CR-5000/8000 SERVICE NOTES**SPECIFICATIONS***First Edition*

Second Printing (July 12, 1983 E2)

**CR-8000
CPU BOARD
GL3125-060
(731250600)
(pcb 2291046401)**

CR-8000
VOICING BOARD
VG3125-120
(7312512007)
(pcb 2291046302)

MODIFICATIONS ON FOIL SIDE
for PCB NO. 2291046400

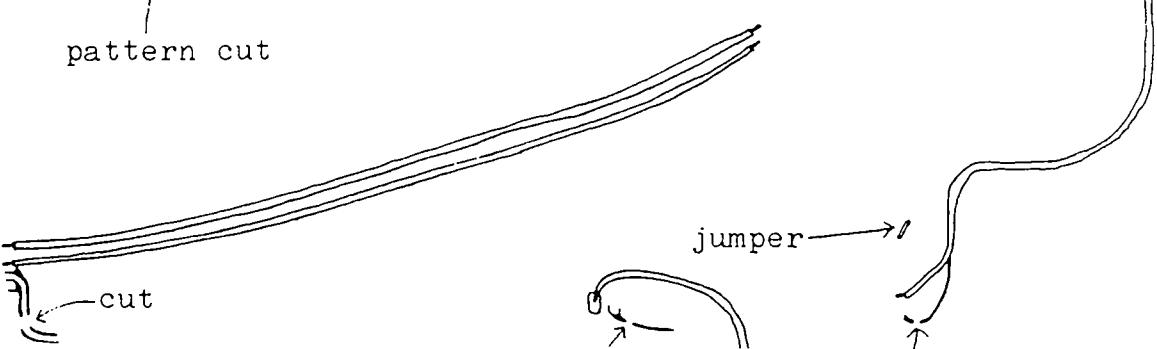
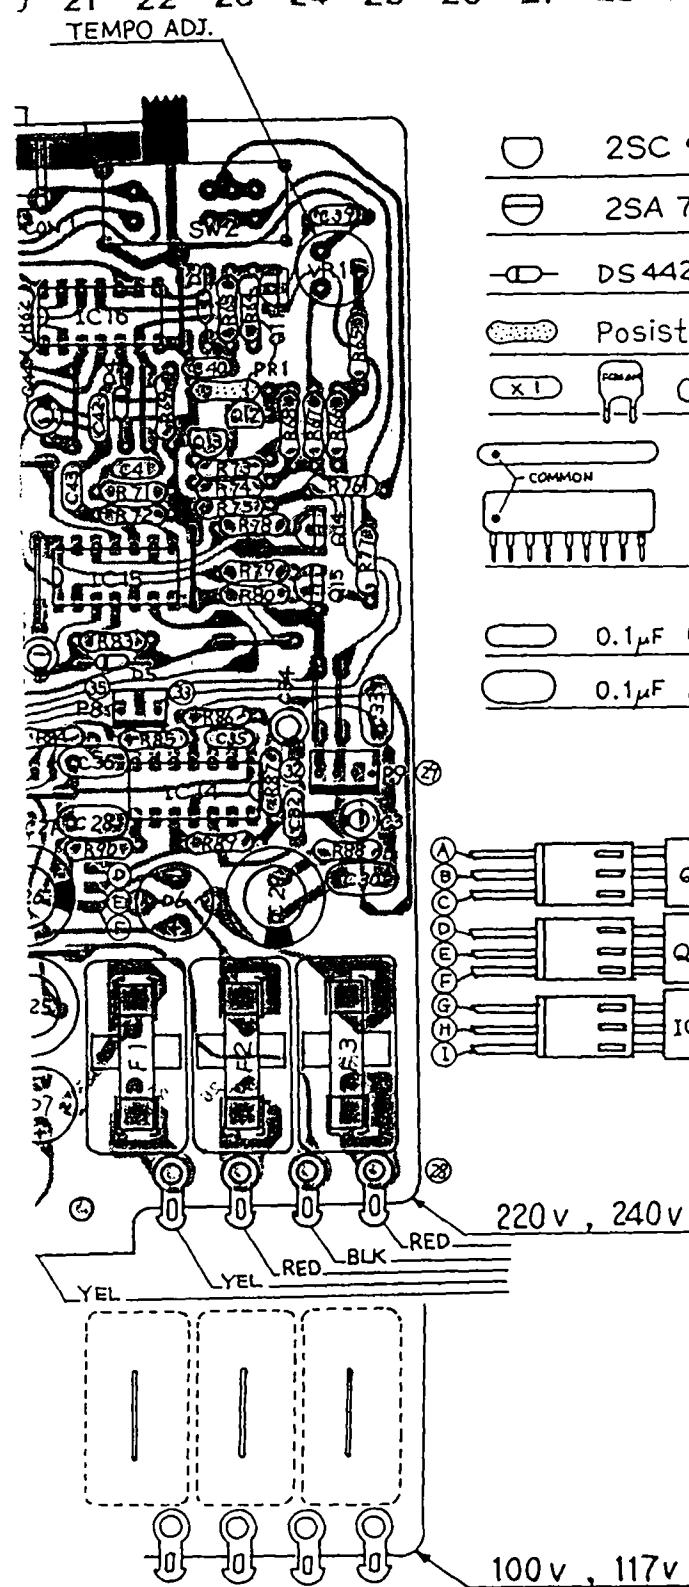
pattern cut

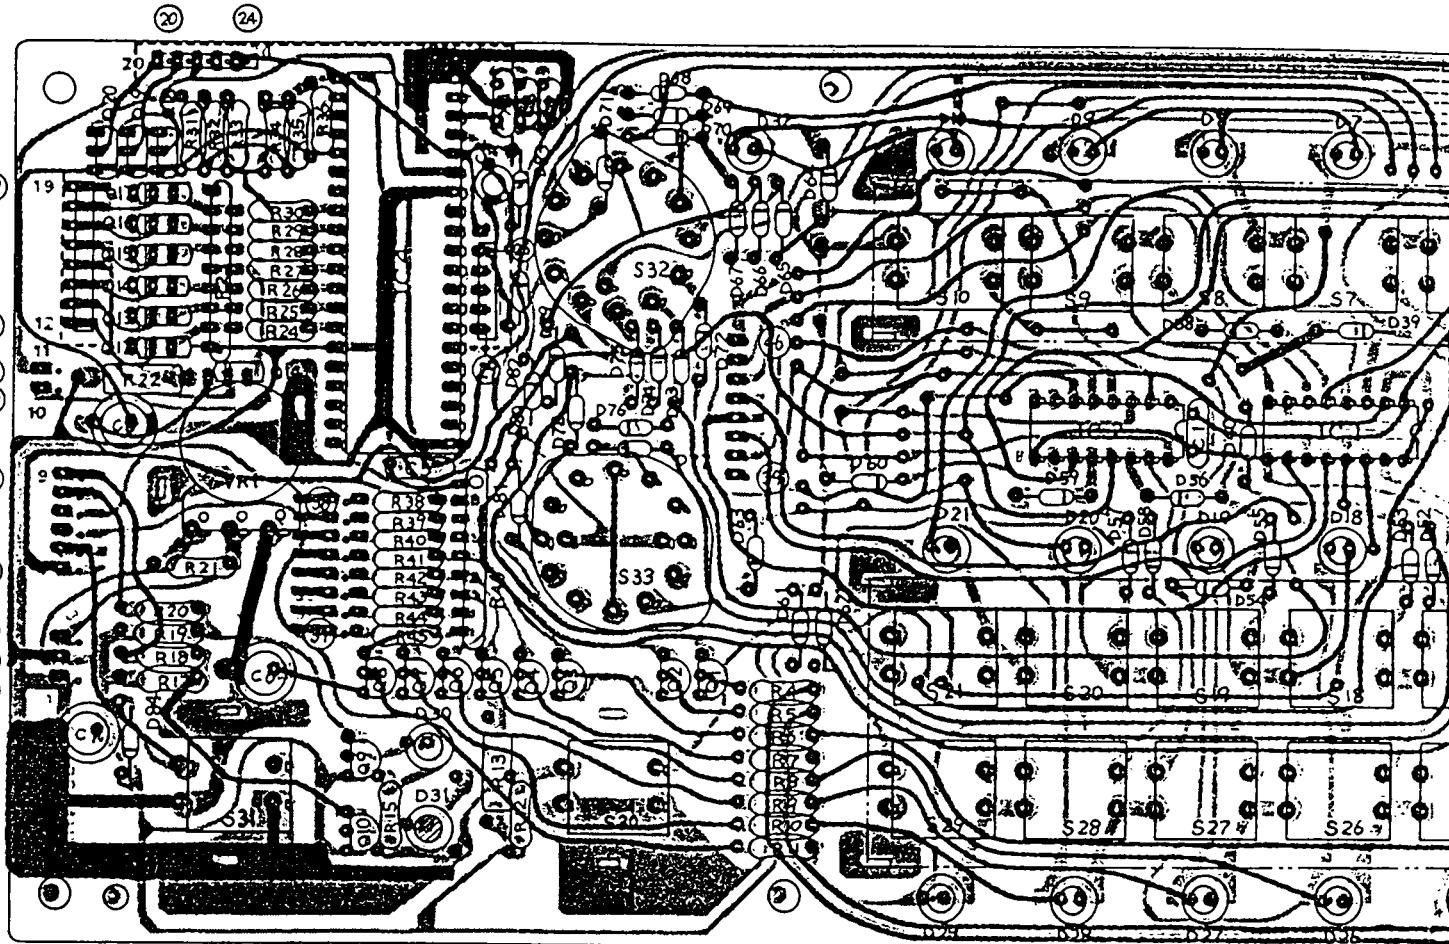
CHANGES IN COMPONENTS

Ensure trigger outputs at IC1 when low V_{OH}
LS273 is used.

R47 47k to 10k
R48 47k to D6
R1 10k to 27k
R61 10k to 27k
R60 10k to 27k

CR-8000

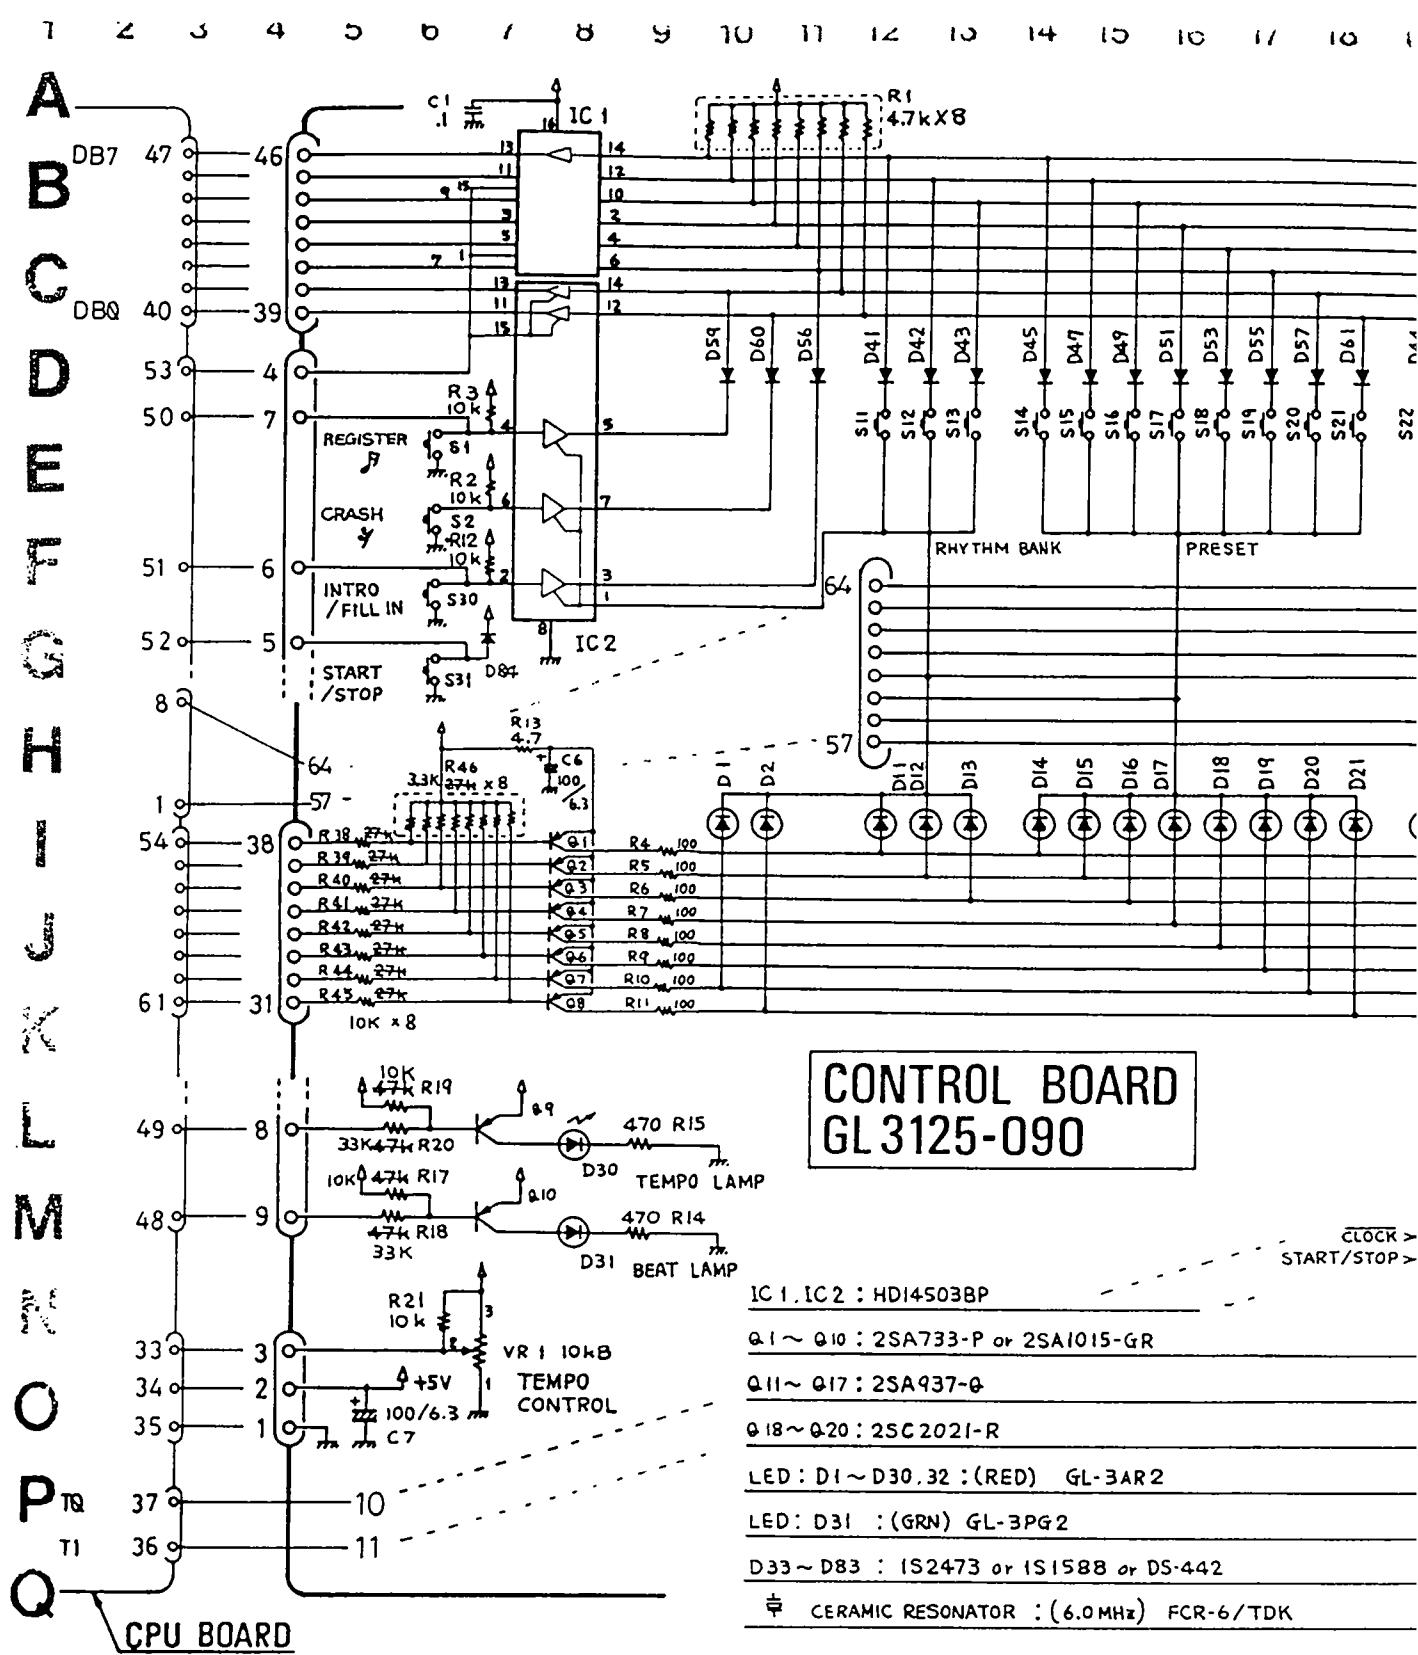
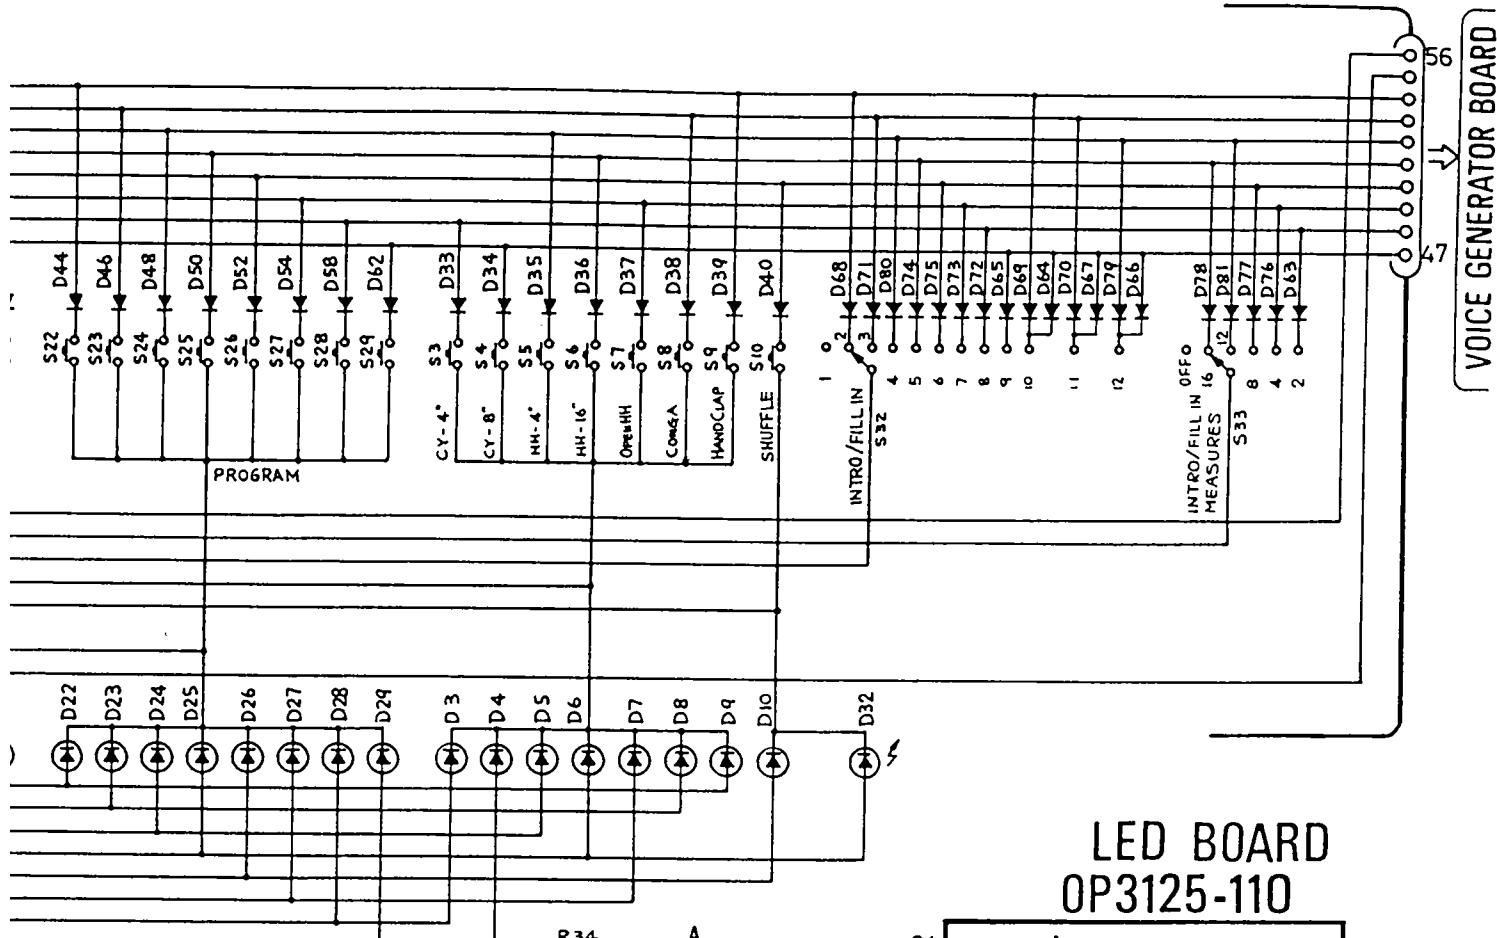
CHANGES IN RESISTANCE With Serial Number 090900 and up

The changes eliminates possible dim lighting of LEDs due to insufficient power at IC1 or IC2 on CPU board:

R38-R45: 27k to 10k R17, R19: 47k to 10k R18, R20: 47k to 3
Resistor Array R46: 27k to 3.3k

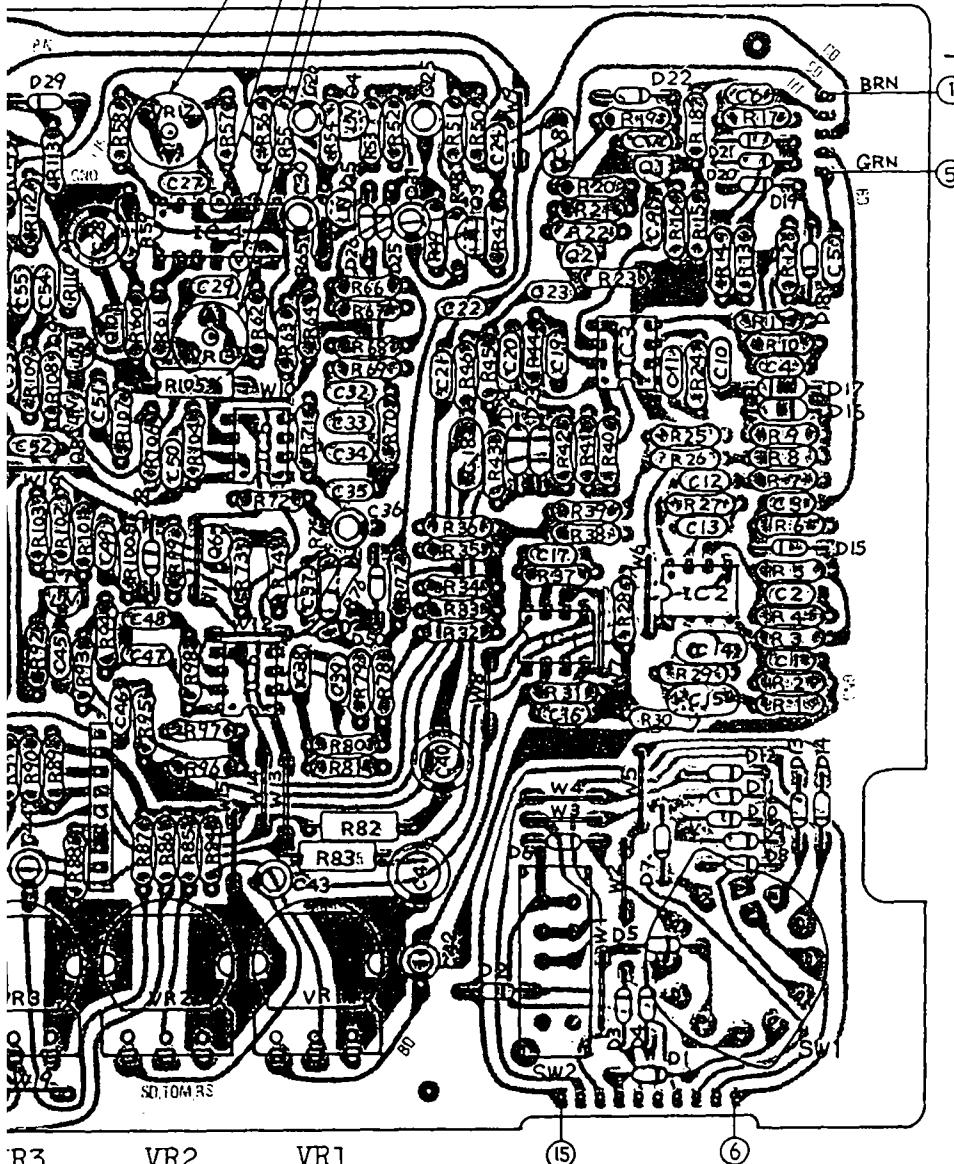
CHANGES IN COMPONENTS

with S/N 090900
 VR9 from 10k to 50k
 Eliminates whizz sound
 upon power off.

with S/N 101300
 R198(HCP) 47k to 33k

with S/N 111700
 R55,56,58,61,63,64
 resistances are increased
 to limit currents into
 IC4. This modification is
 mandatory when replacing
 defective IC4.

CR-5000
CPU BOARD
GL-3124-060
(7312406008)
(pcb 2291046401)

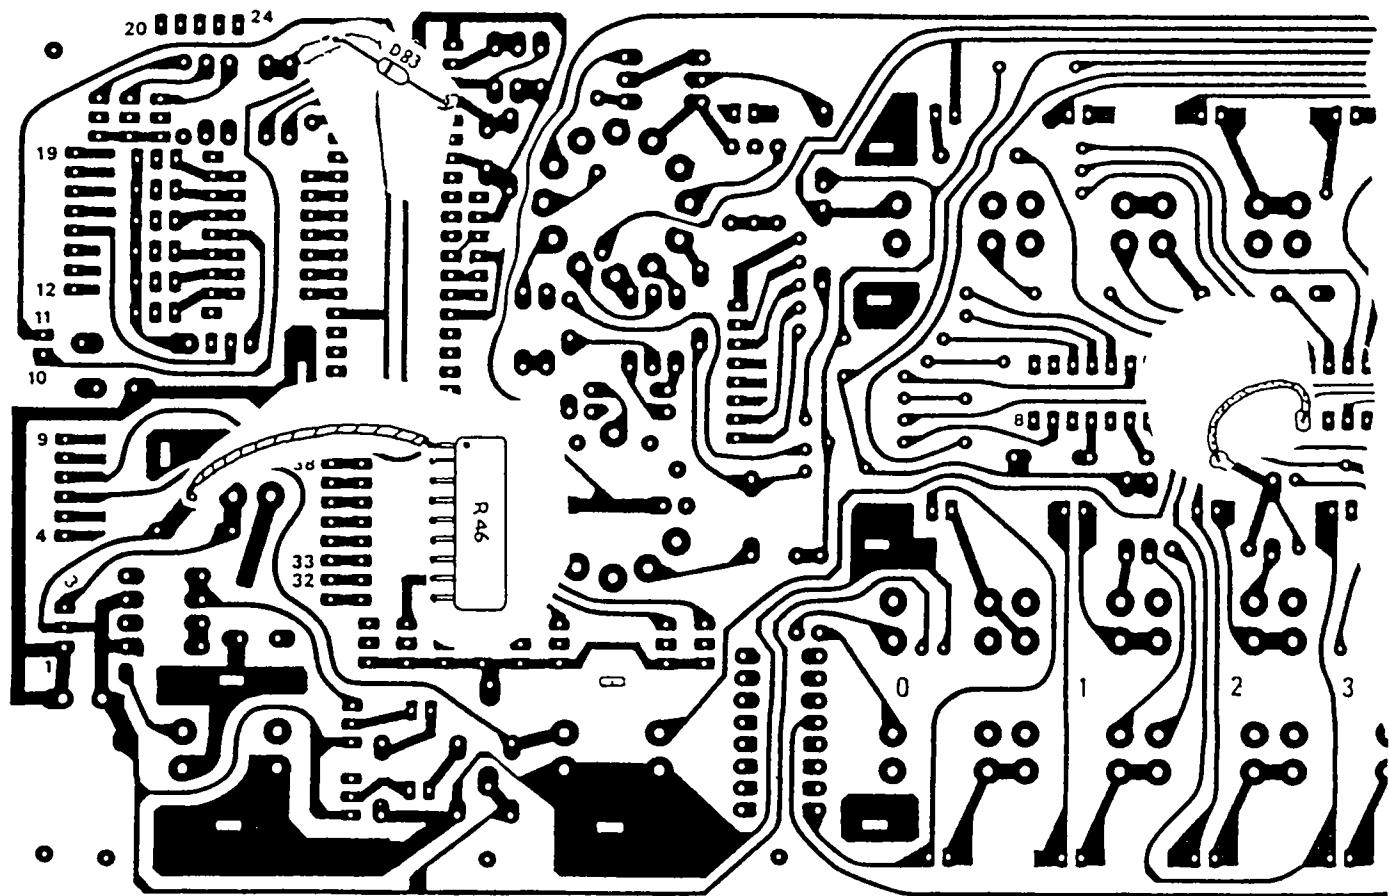
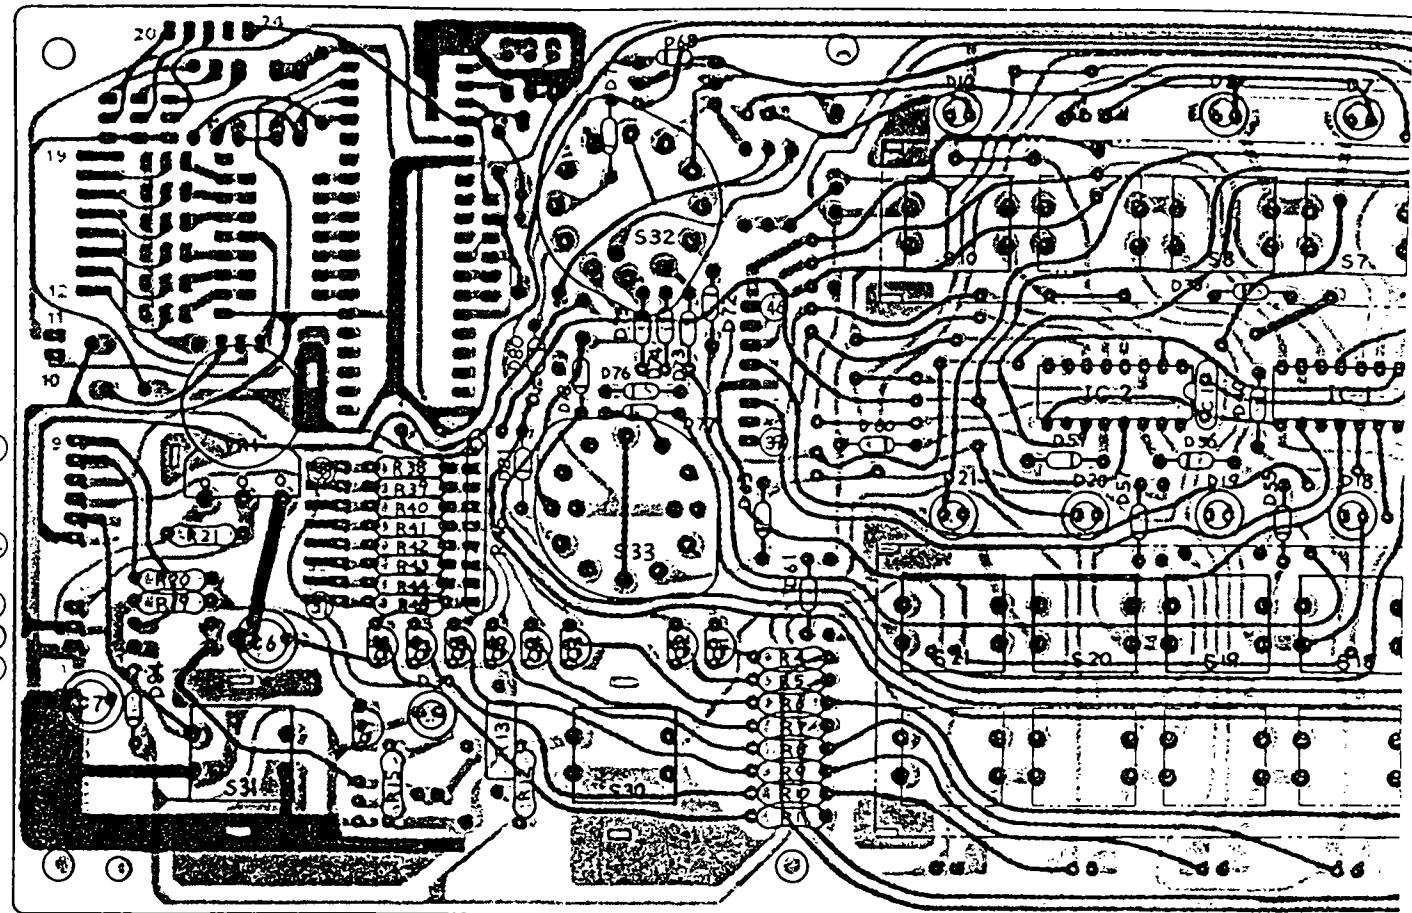
CHANGES IN COMPONENTS

Ensure trigger outputs at IC1 when low V_{OH}
 LS273 is used.

R47 47k to 10k
 R48 47k to D6
 R1 10k to 27k
 R61 10k to 27k
 R60 10k to 27k

Prevents possible oscillation at final amp upon power off

C29: 470 μ F to 100 μ F
